**ADDENDUM NUMBER 4 ON INVITATION TO BID ITB20KO-136**

**TITLE:** IFAS Demonstration Pavilion – Live Oak, FL

**Responses to Contractor Questions and Requests for Clarification**

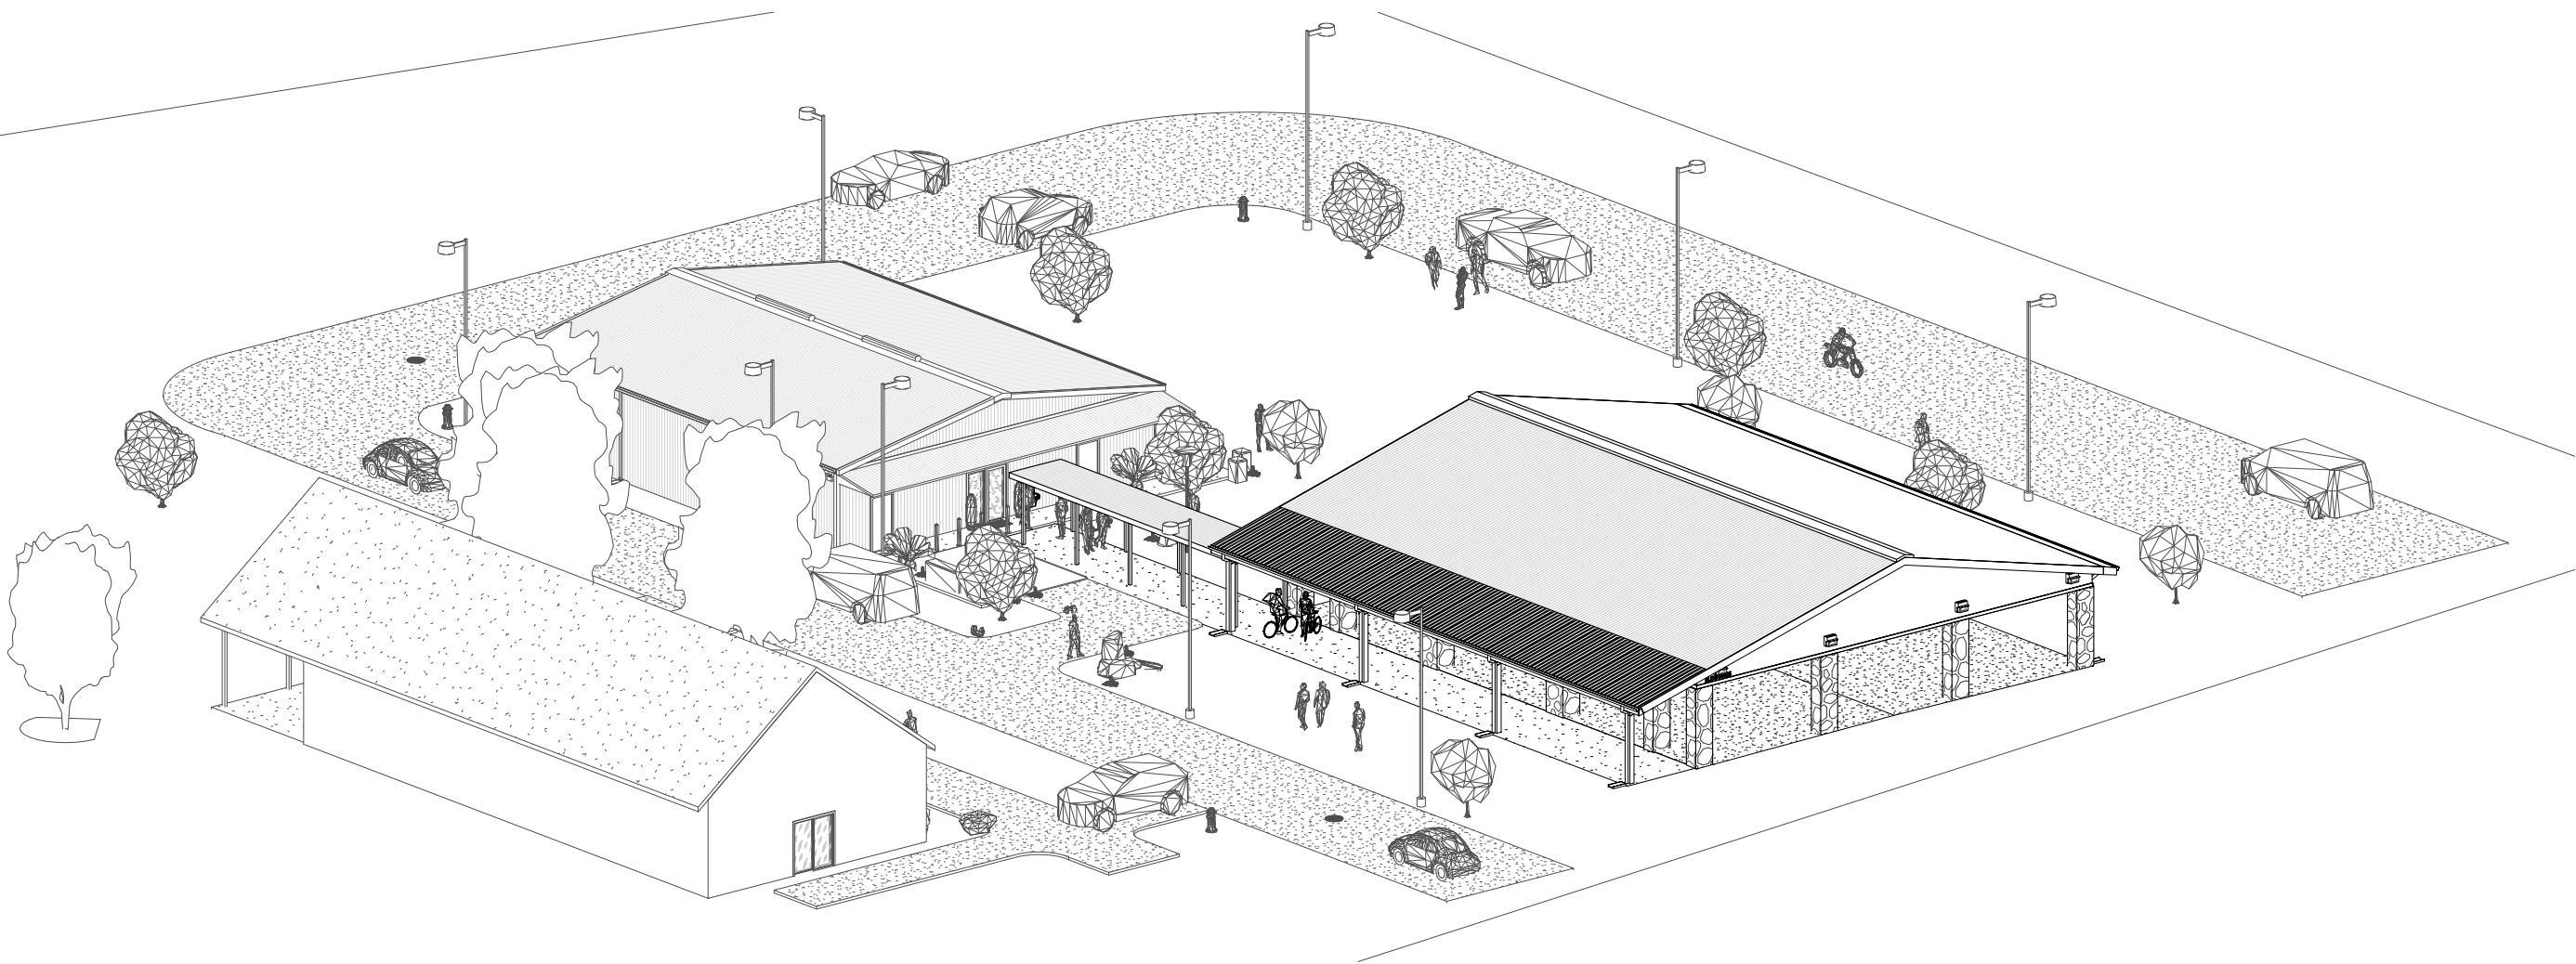
Q12. Please clarify what items from the civil plan are in Lot 1 vs Lot 2.

A12. Reference attached plan C-210 clarifying this item.

SHEET TO.0
COVER SHEET
1460-30

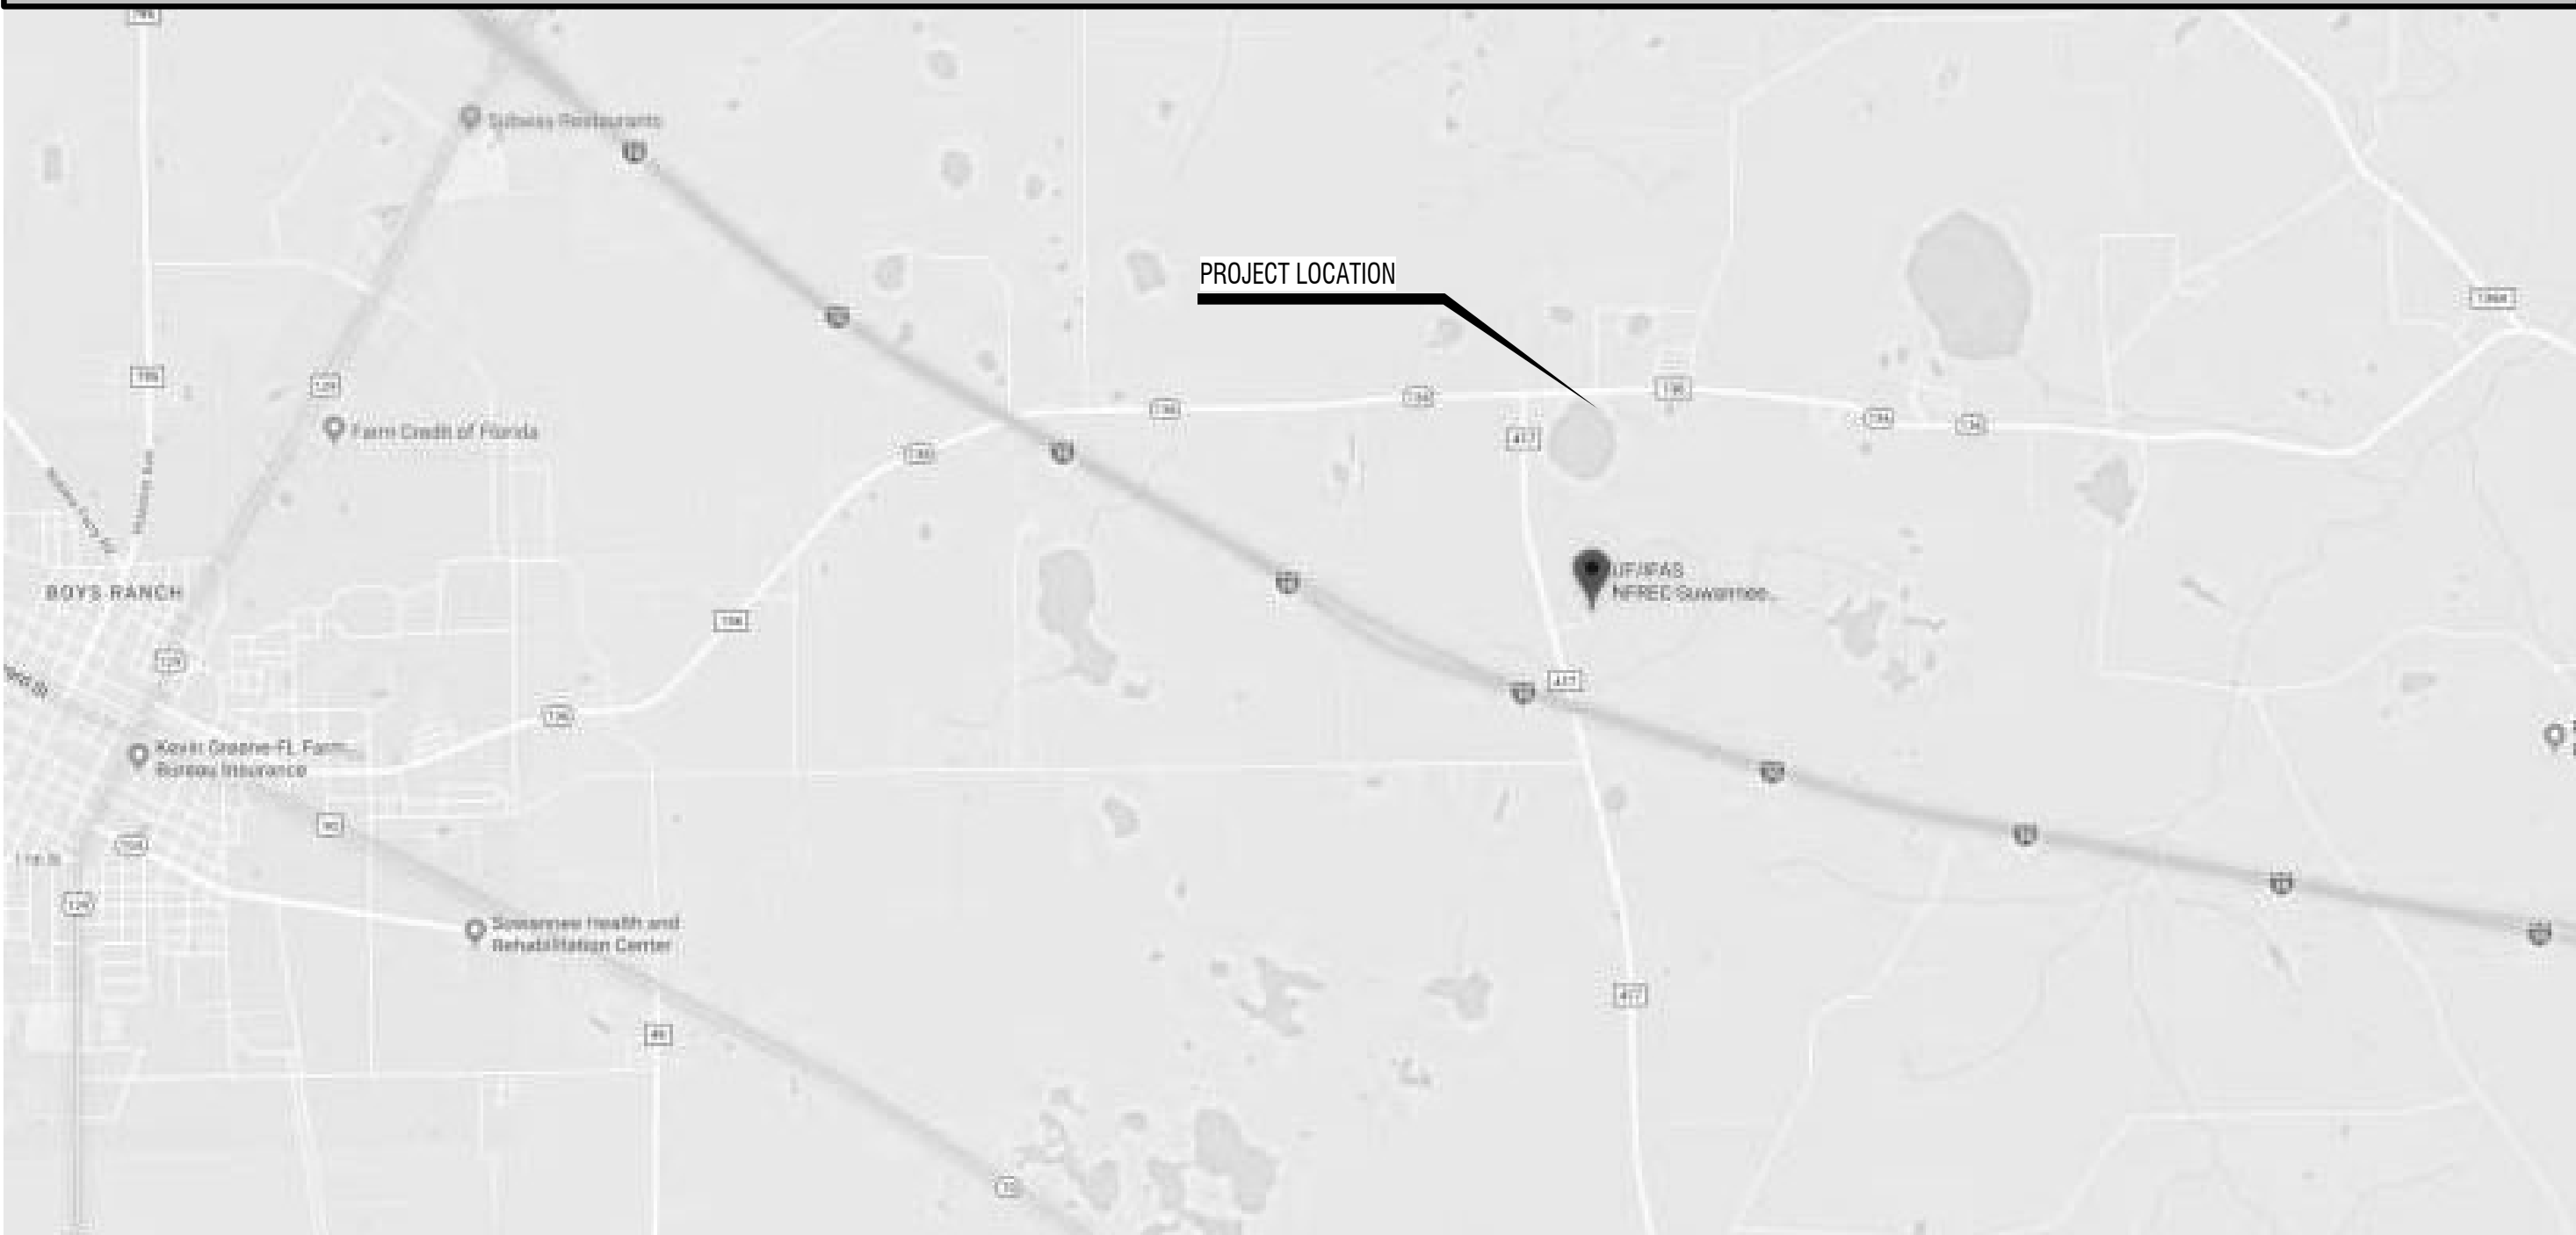
Q15. On sheet T0.0, the 3D plan shows landscaping. There are not any landscape & irrigation drawings. Please clarify scope if any.

A15. Landscaping is not in scope.

SHEET  
LS1.0  
PROPOSED - LIFE  
SAFETY -  
OVERALL  
1460-30

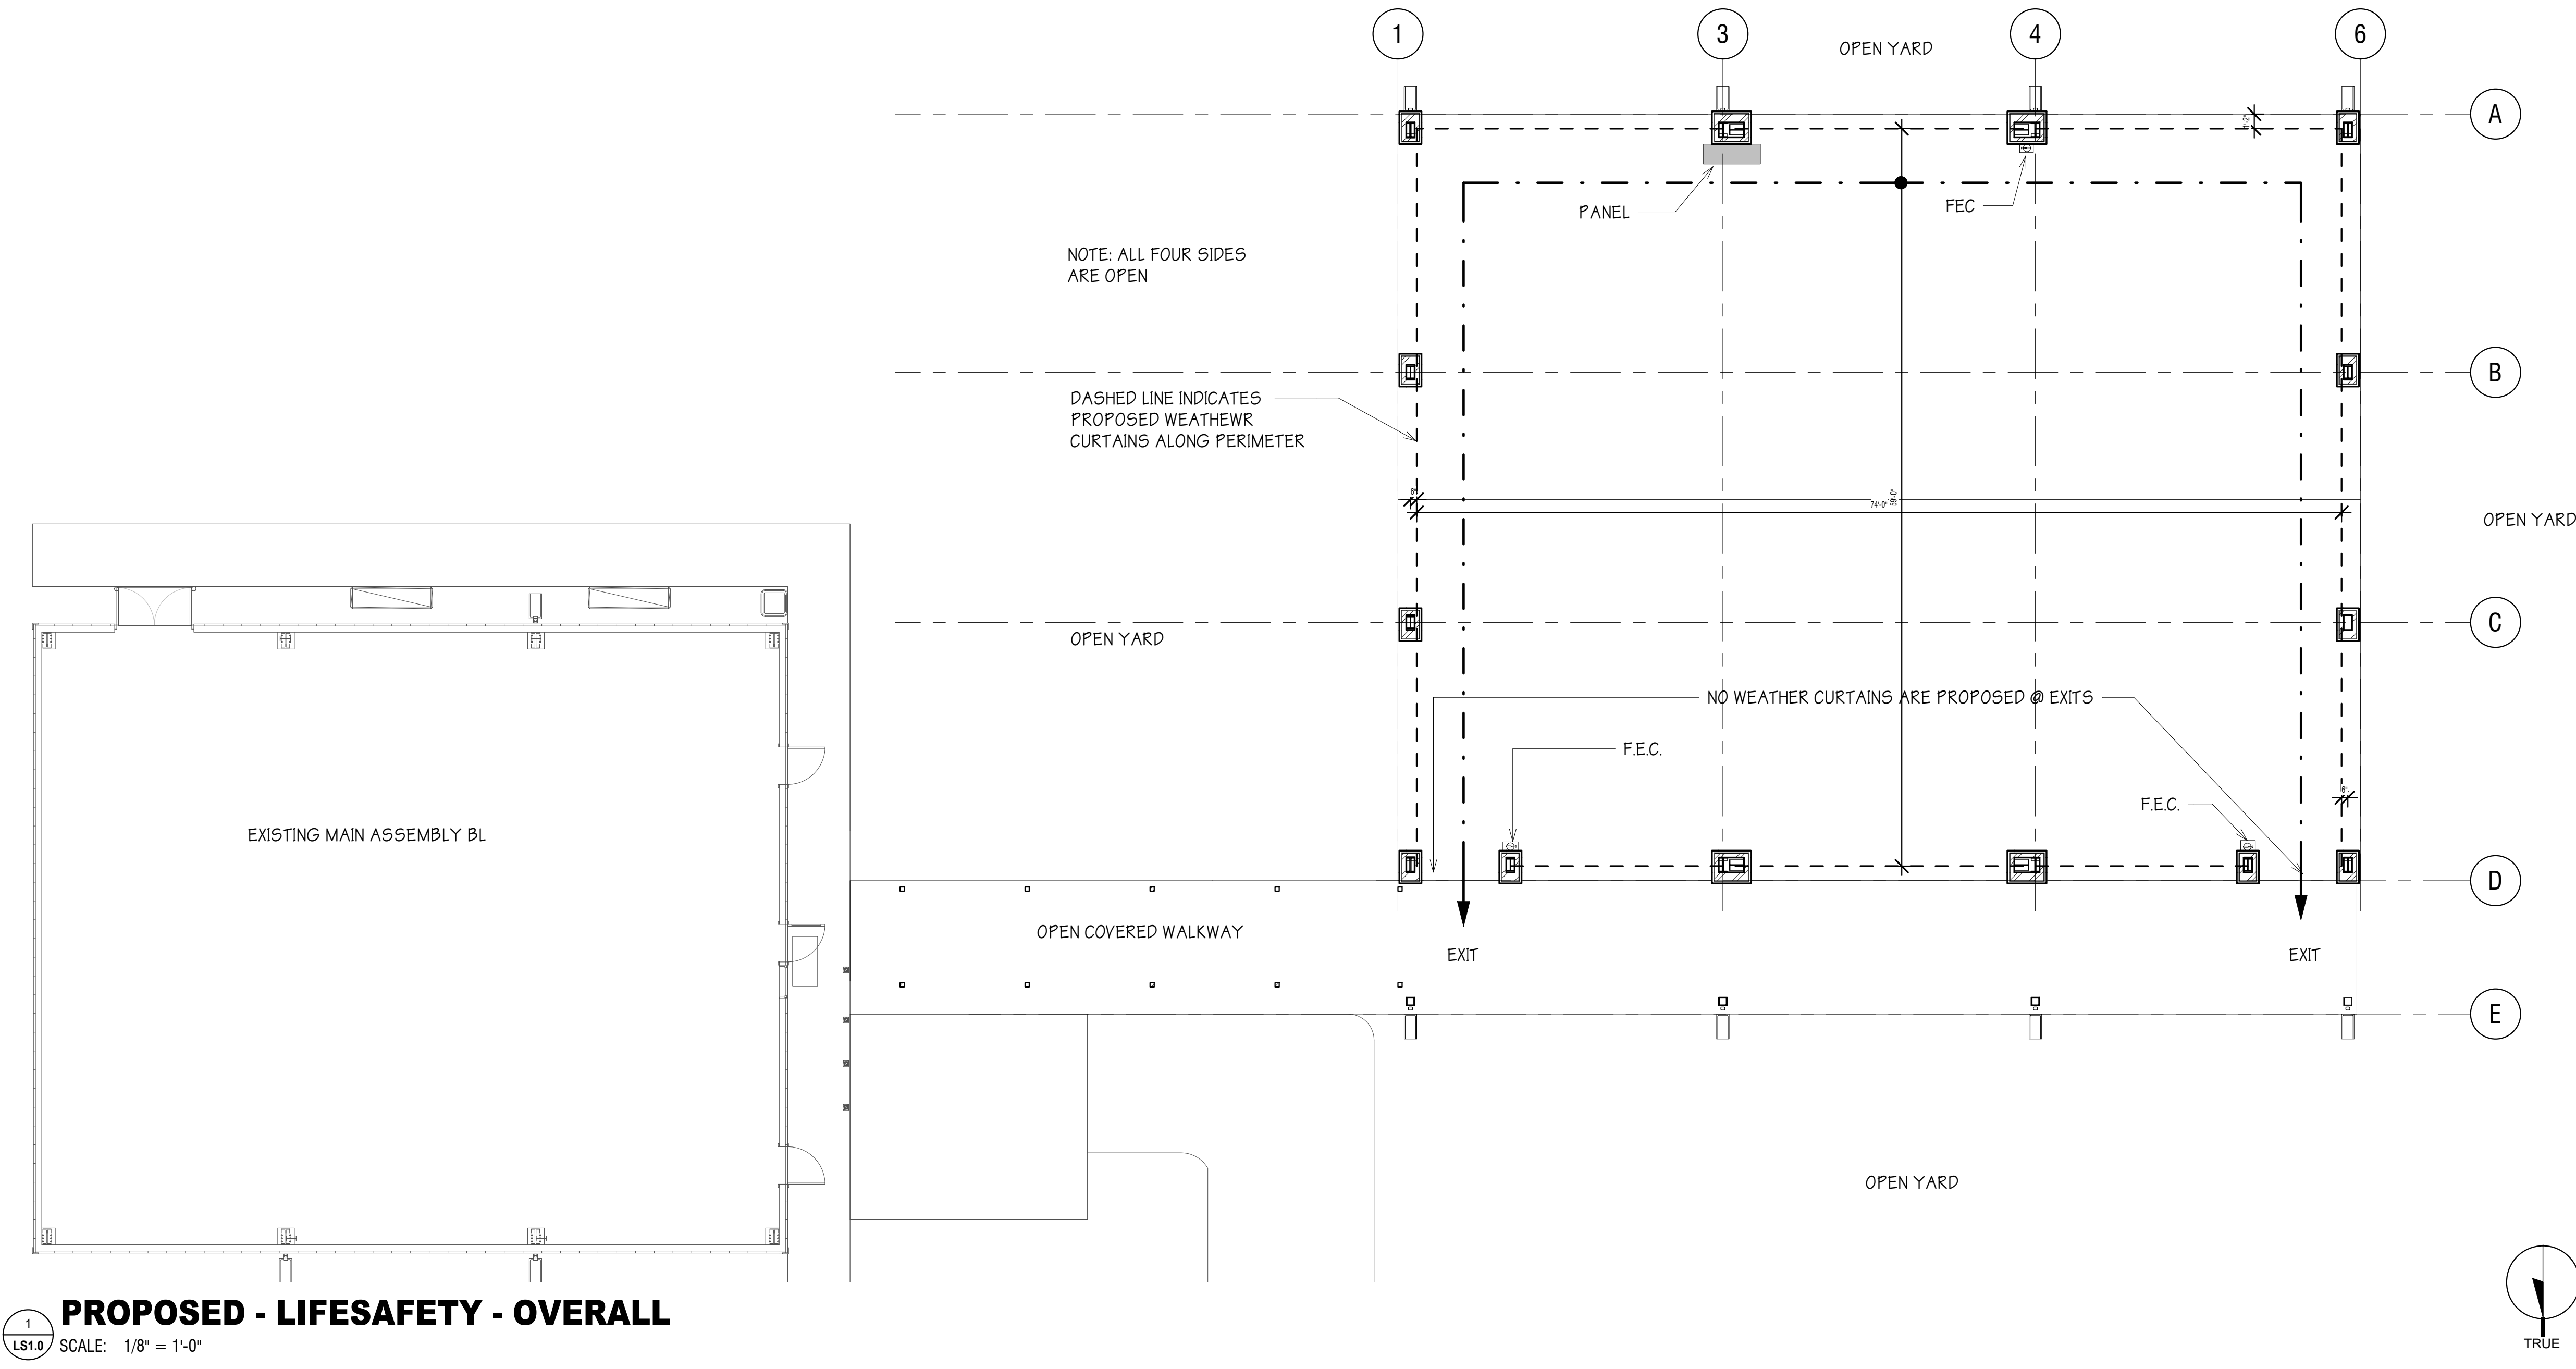
Q4. The specifications call out for fire extinguishers and AED's. Both are not shown on drawings, please clarify if they are needed on this project.

Q5. Section 10520 subsection 2.C "automatic external defibrillators" states "include the addition of one or more AED 's, with the cabinet(s) specified, furnished, and installed by the project and the device(s) themselves purchased by the project and installed by UF EH&S. Consult with the EH&S during design regarding type/size, quantity, and location(s)." Please clarify this scope of work.

A4. Reference LS1.0. Three (3) fire extinguishers are indicated. Spec 10520 calls for one (1) AED. Owner to supply and Owner to install.

A5. Reference LS1.0. Three (3) fire extinguishers are indicated. Spec 10520 calls for one (1) AED. Owner to supply and Owner to install.
